Technical Service Bulletin: TSB190158

Engine Cooling Fan Will Not Disengage: New Rockford Fan Clutch Solenoid

Figure 2, New Rockford Fan Clutch Solenoid.

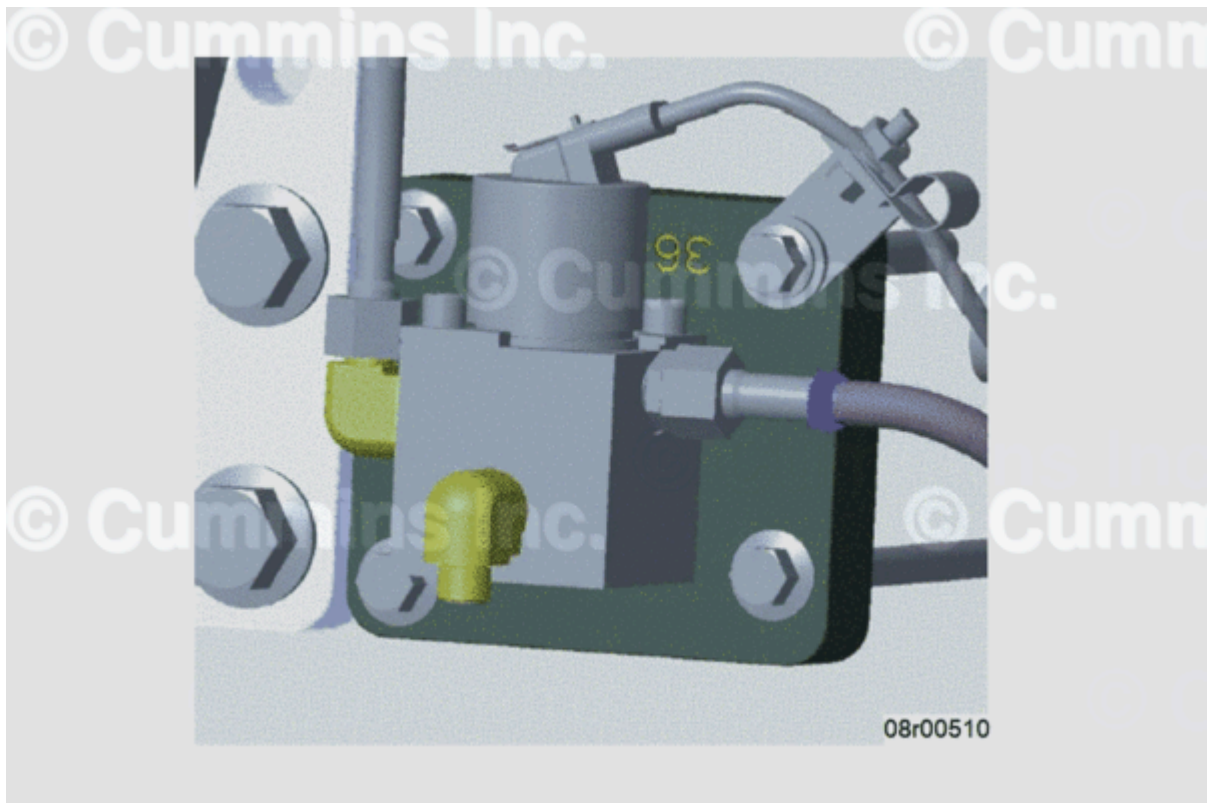
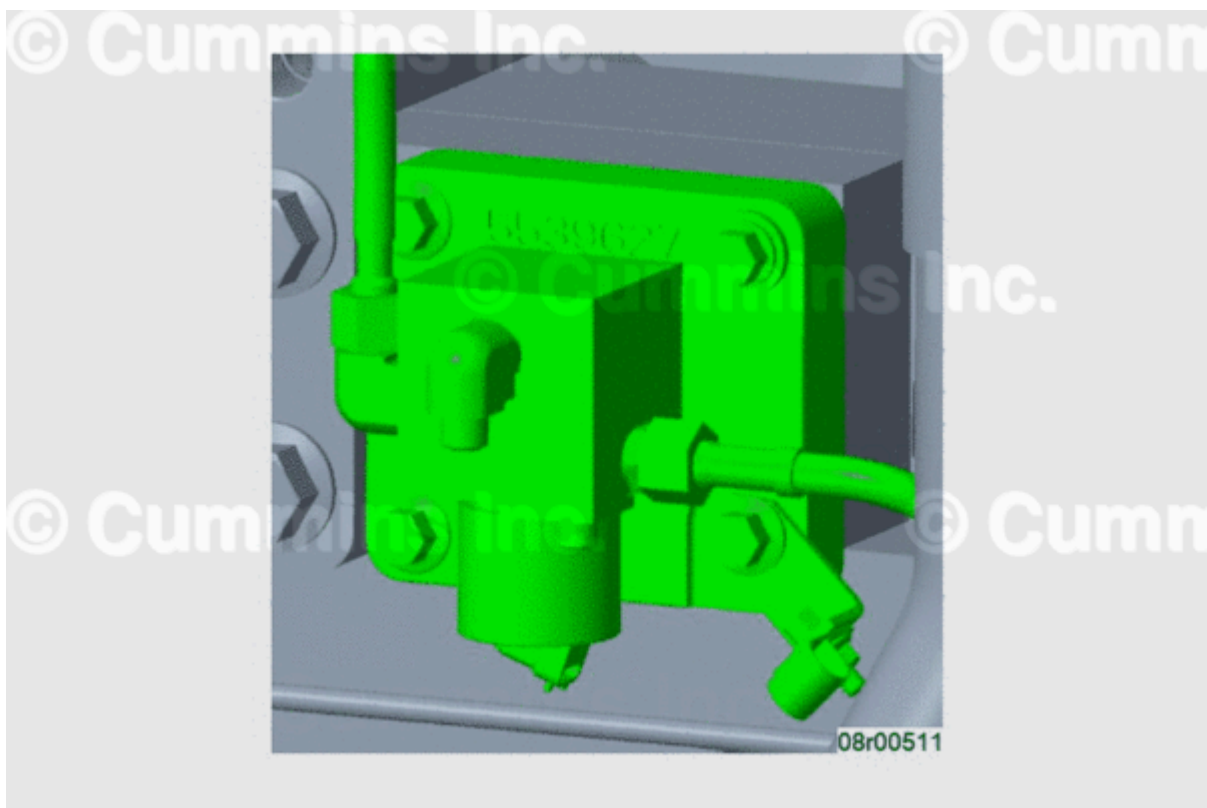
- A new rotated fan clutch solenoid part number has been released. The new fan clutch solenoid is mounted 180 degrees from the existing position, see Figures 1 and 2 below. See Table 1 below for part number.

Figure 3, Location of New P-Clip and Shortened Capscrew.

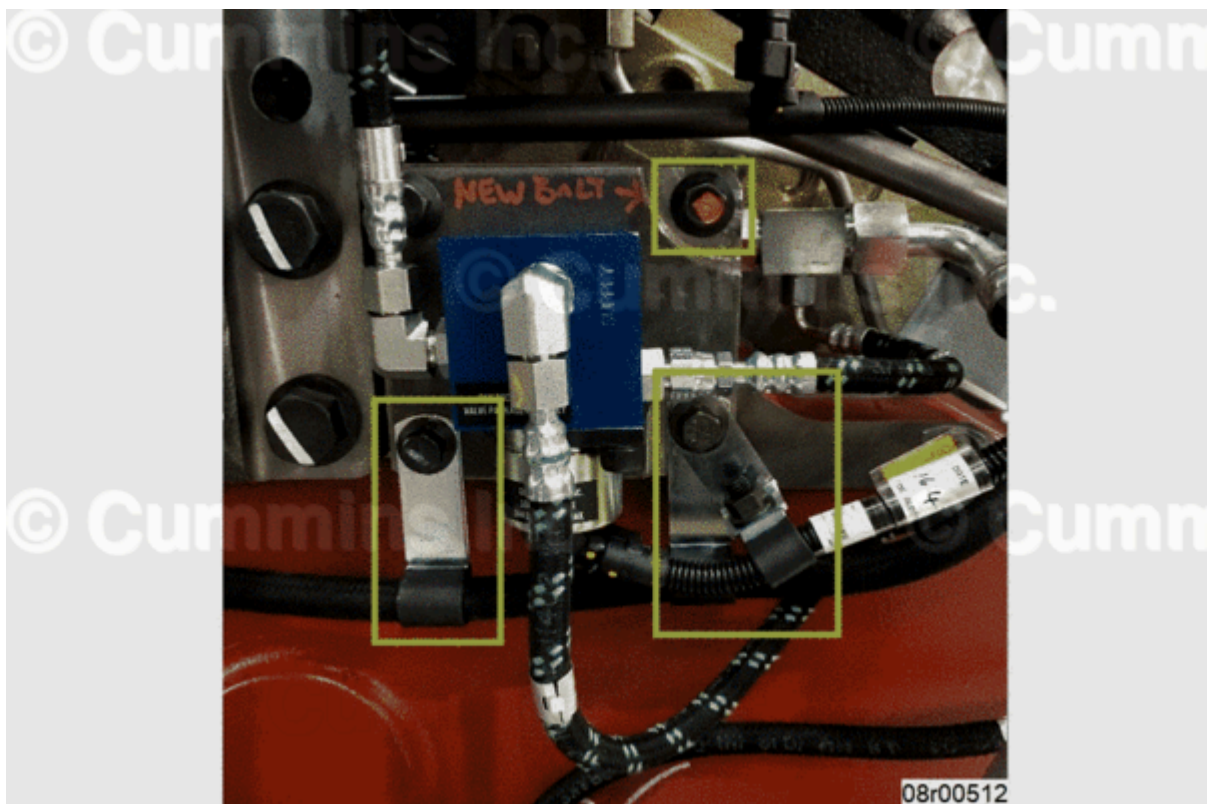
- A new fan clutch solenoid mounting plate part number has been released to enable the rotated fan clutch solenoid to be mounted in the same location. See Table 1 below for part number.
- The new fan clutch new solenoid has the control and sump ports flipped compared to the existing fan clutch solenoid, so the flexible hoses do **not** need to be changed and remain on the same side when the fan clutch solenoid is rotated 180 degrees.
- The top right capscrew has also been changed. See Figure 3 below. Due to the removal of the need for the P-clip in this location, a shorter capscrew is now used in this location, and the washer removed; to avoid the capscrew bottoming out.
- For QSK60 CM500 engines **only**, a new p-clips are used to hold the fuel hose that runs underneath the fan clutch solenoid, see Figure 3 below.
